GNRO-2011/00043

SUBJECT: Request for Additional Information Regarding
Extended Power Uprate
Grand Gulf Nuclear Station, Unit 1
Docket No. 50-416
License No. NPF-29

Grand Gulf Nuclear Station Extended Power Uprate

Response to Request for Additional Information

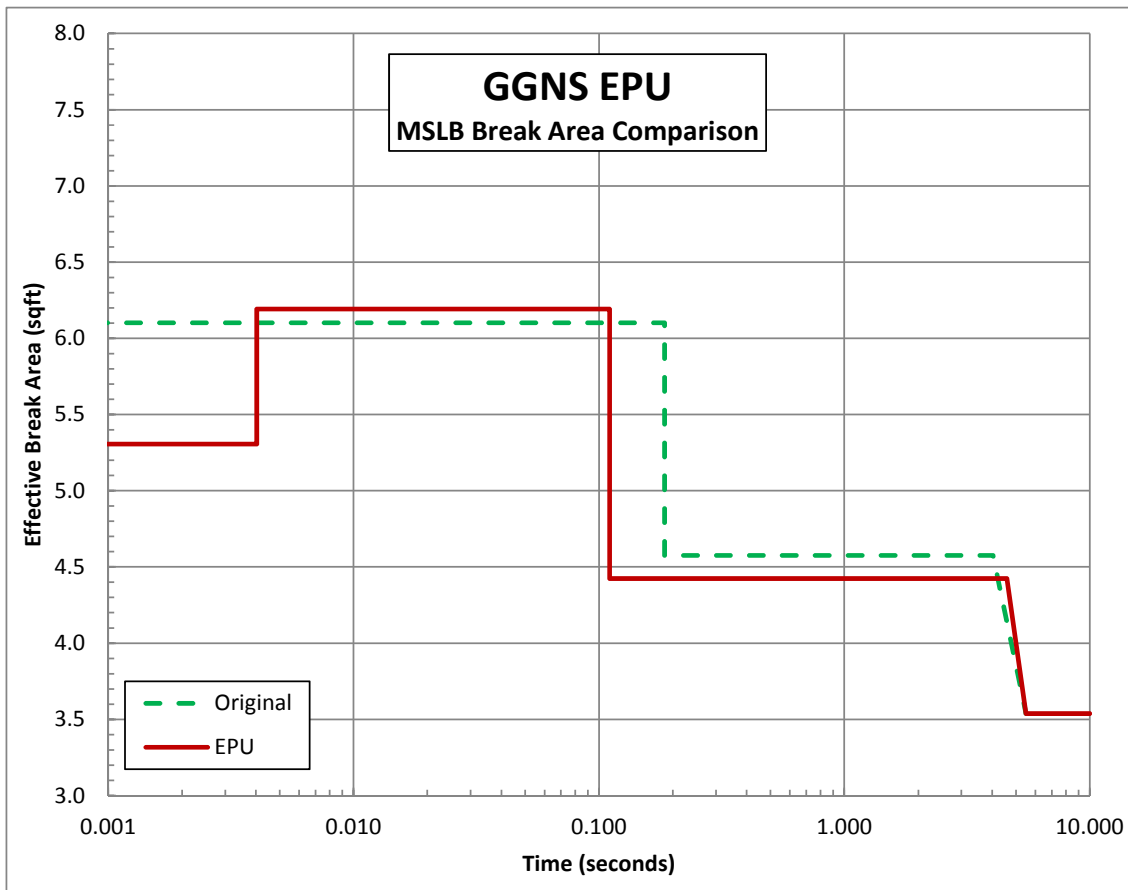
With regards to letter dated March 31, 2011, response to RAI No. 1(b), provide the reasons for differences in the model for the MSLB area in the EPU analysis from the current licensing basis break area model given in UFSAR Figure 6.2-9. Explain the methodology used for calculating these flow areas as a function of time.

The most significant reason for the change in break area used in the EPU analysis as compared with the original analysis illustrated in the GGNS UFSAR Figure 6.2-9 is a change in the flow area of the Main Steam Line Flow Limiter. In the original analysis, the flow limiter area was assumed to be 1.037 sq ft, which was based on preliminary design information. As-built drawings indicate the internal diameter of the GGNS flow limiter is 12.747 inches, giving a flow area of 0.8862 sq ft.

The original analysis used a nozzle safe end area of 3.538 sq ft, a main steam line area of 3.449 sq ft, and a flow limiter area of 1.037 sq ft. The original analysis also assumed main steam isolation valve (MSIV) closure began at 0.5 seconds and achieved full closure at 5.5 seconds. The original analysis included a flow multiplier of 0.75 applied to the reactor-side break area, but did not include such flow multiplier for the main steam line-side break area. This flow multiplier is used during the time that flow from the break is experiencing a pressure wave that travels from the break location back to the source.

For the EPU analysis, current plant drawings show the nozzle safe end area to be unchanged from the original analysis, 3.538 sq ft. But current drawings indicate the main steam line flow

area to be the same as that of the nozzle safe end, or 3.538 sq ft, instead of the 3.449 sq ft used in the original analysis. As mentioned above, current as-built drawings also indicate that the main steam flow limiter area is 0.8862 sq ft, instead of 1.037 sq ft used in the original analysis. In addition, the EPU analysis includes use of the 0.75 flow multiplier on the main steam line-side break area as well as on the reactor-side break area during the times that lines are experiencing the pressure wave back to their sources. The EPU analysis also includes MSIV closure begins at 0.5 seconds and achieves full closure at 5.5 seconds, just as in the original analysis.

The following figure provides a graphic comparison of the effective break areas assumed in the original and in the EPU analyses. Please note that the reduction in break size at approximately 0.11 seconds is correctly reflected below. The table that was provided in response to Item 1.d in the March 31, 2011 response had misplaced the decimal point and incorrectly shown this time step as 0.0110394 seconds.
